Addendum 1

City of Canton, Ohio
Purchasing Department
218 Cleveland Ave. SW, 4th floor
Canton, Ohio 44702

Collection Systems Service Center Garage Addition and Administration Offices
Renovation

DWG
E-2.2

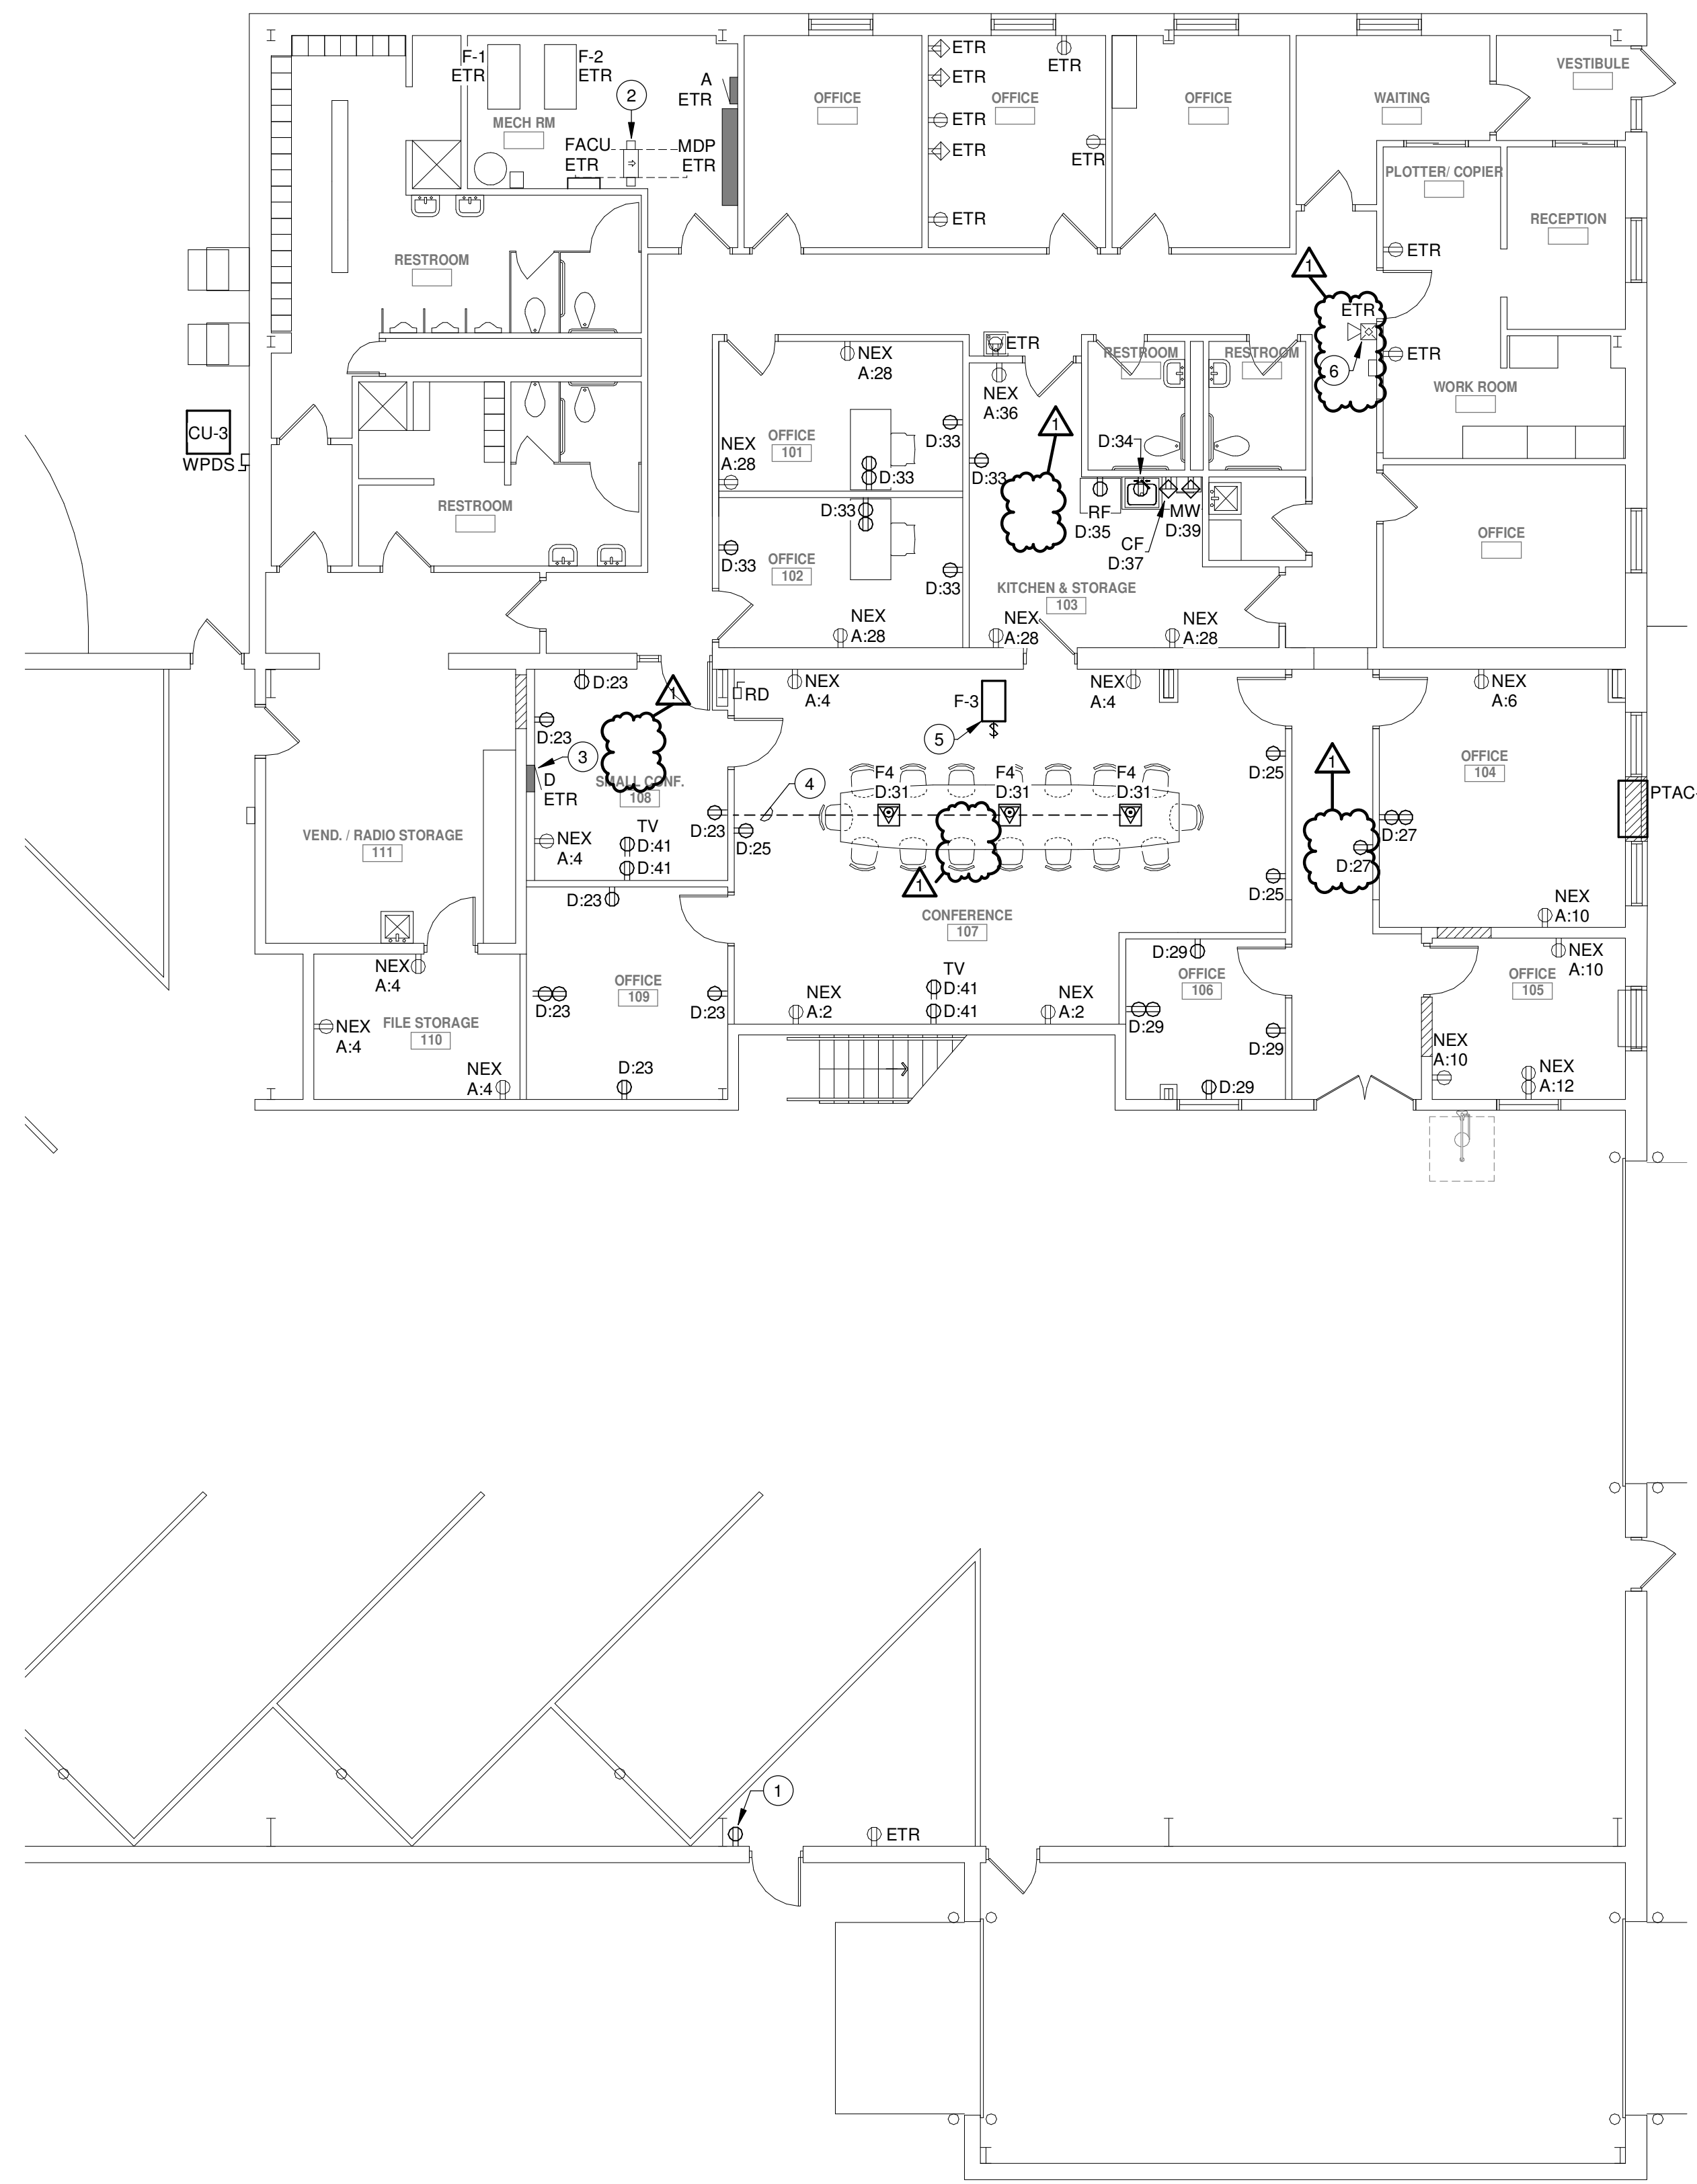
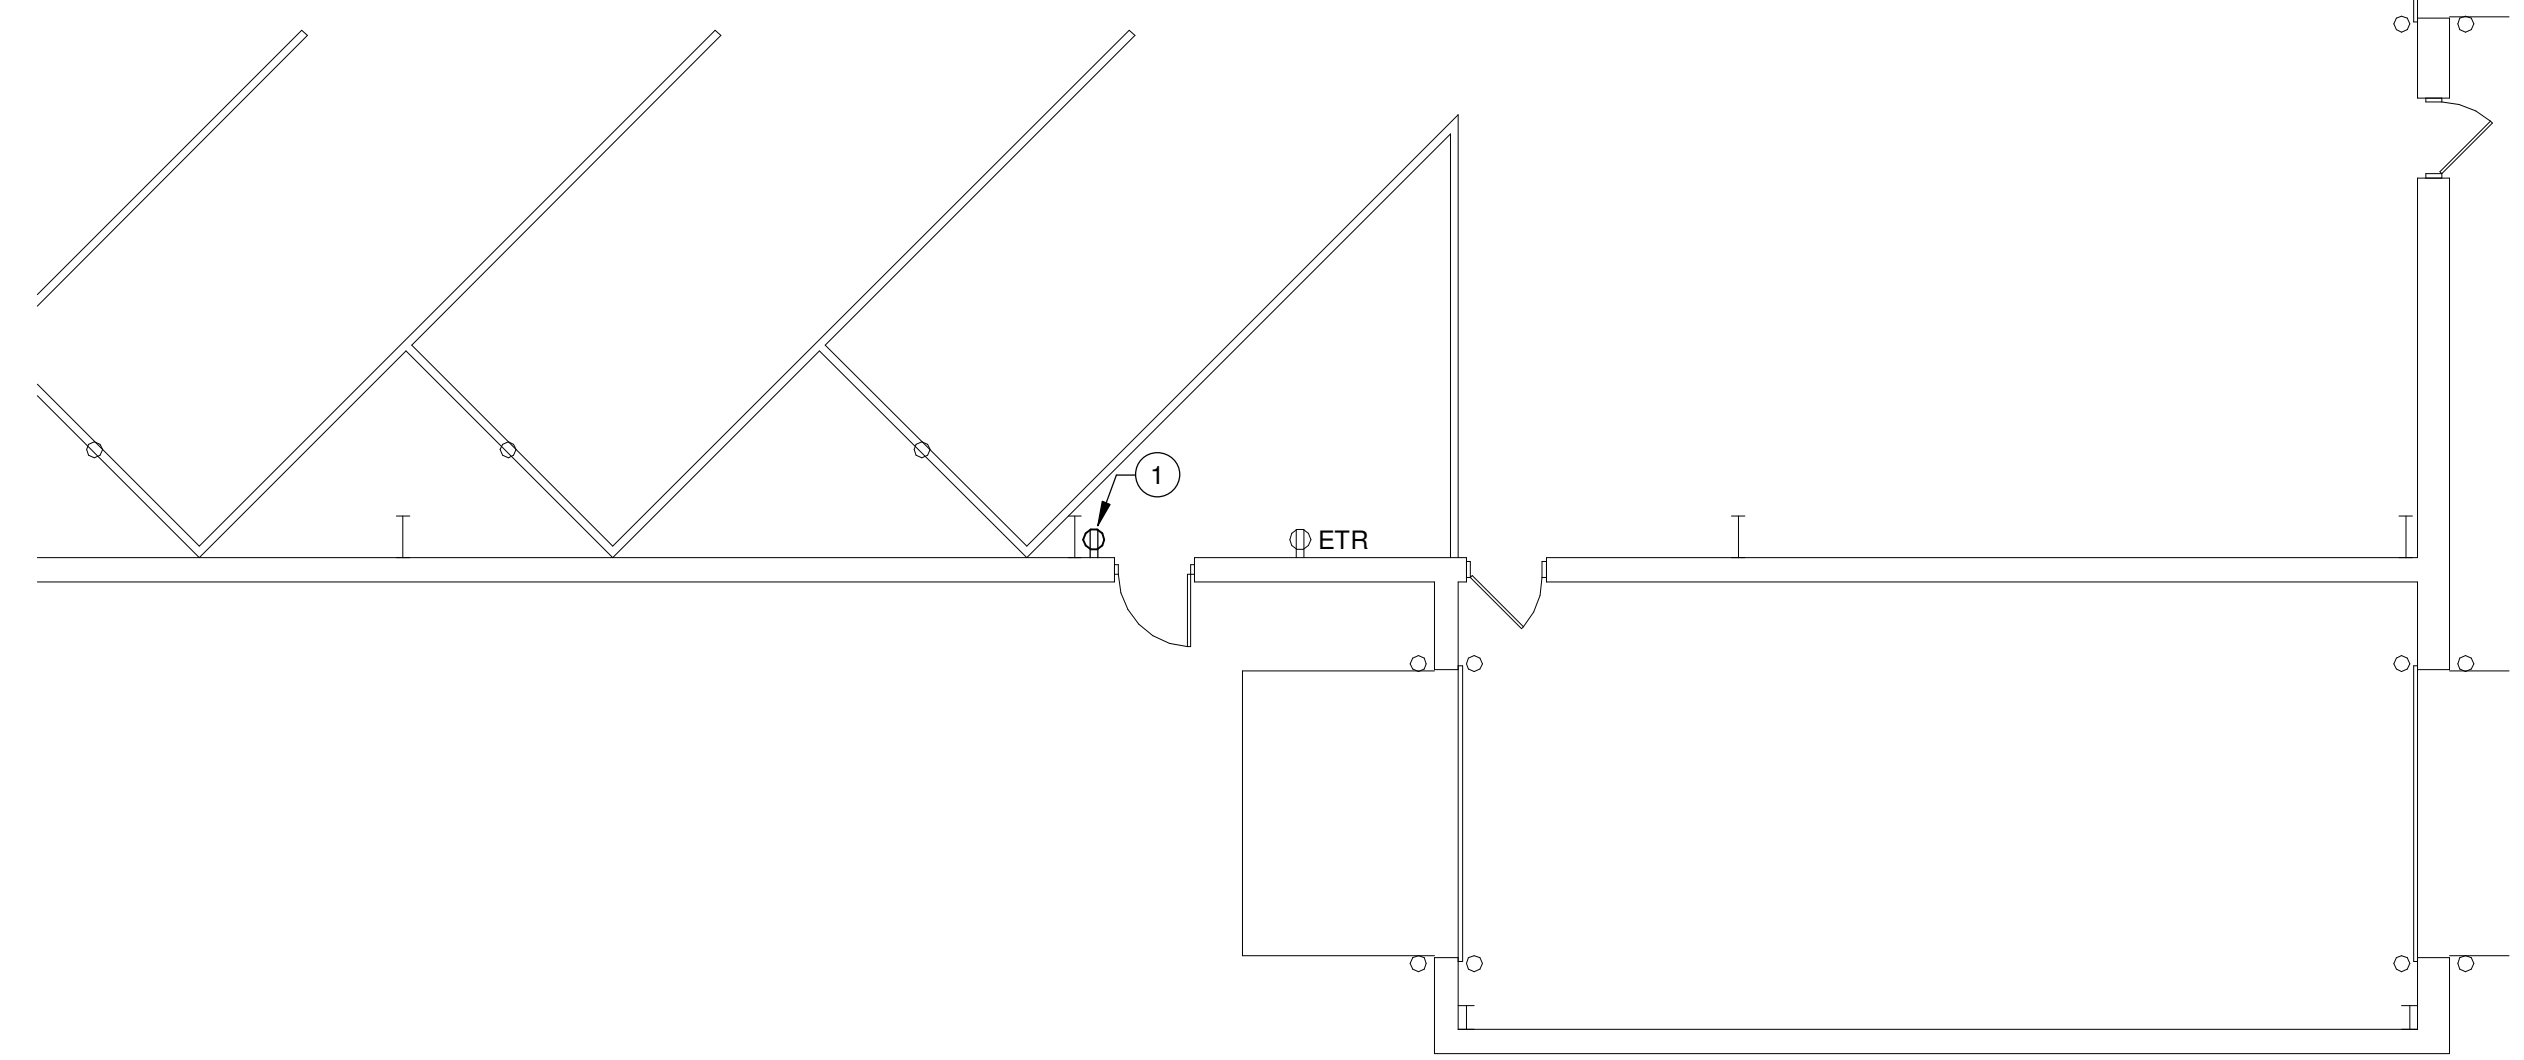
Drawing E-2.2 Note 3 calls out supplying a new panel cover for existing panel D. Who is the manufacturer and what is the model number of the panel?

E-2.2 Removed (4) area fire alarm A/V notification devices and added plan note 6.

The intent of replacement of the cover is to provide a cover that will engage in furred stud and drywall to be installed to surround the existing surface mounted panel.

Manufacturer: Eaton / Cutler Hammer

Model: Box Catalog No. EZB 2036R Type 1 Enclosure with EZ Trim, Door in Door,

Concealed Hardware: EZT2036S
